Correspondence Between Staff and Applicant

## 14-ZN-2019 1<sup>st</sup> Review Stormwater Comments:

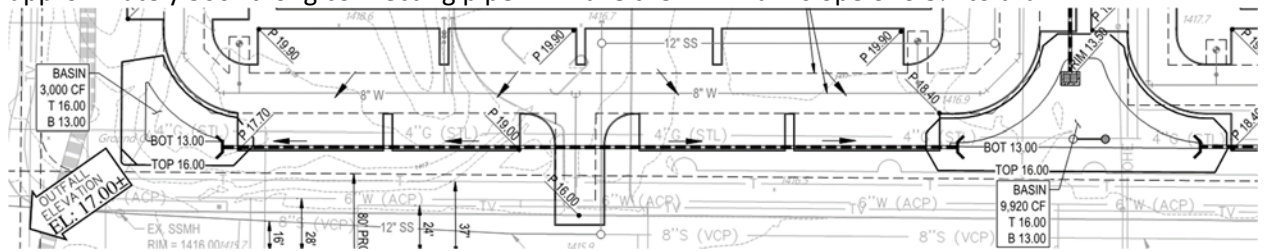
2. Provide a breakdown of stormwater storage calculations per basin along with an exhibit showing the tributary areas for each basin so that runoff volumes can be verified. Provide an exhibit demonstrating how various runoff coefficients were used for the areas draining to each proposed basin.
3. Provide the top and bottom elevations of the proposed underground stormwater storage tank (USST). Demonstrate how it can drain via gravity.
4. Some proposed stormwater basins do not have a means to drain by gravity. For example, as shown below, the basin with a bottom elevation of 23.0 has a proposed drywell; however, the basin with a lower bottom of 22.0 has no means to drain.

In the following example, the basin to the west is intended to be equalized with the basin to the east, which is to drain via drywell. However, in order to drain properly and avoid standing water, the basin to the west should have a bottom that is almost two feet higher so that the approximately 360-ft long connecting pipe will have the minimum slope of 0.5% to drain.
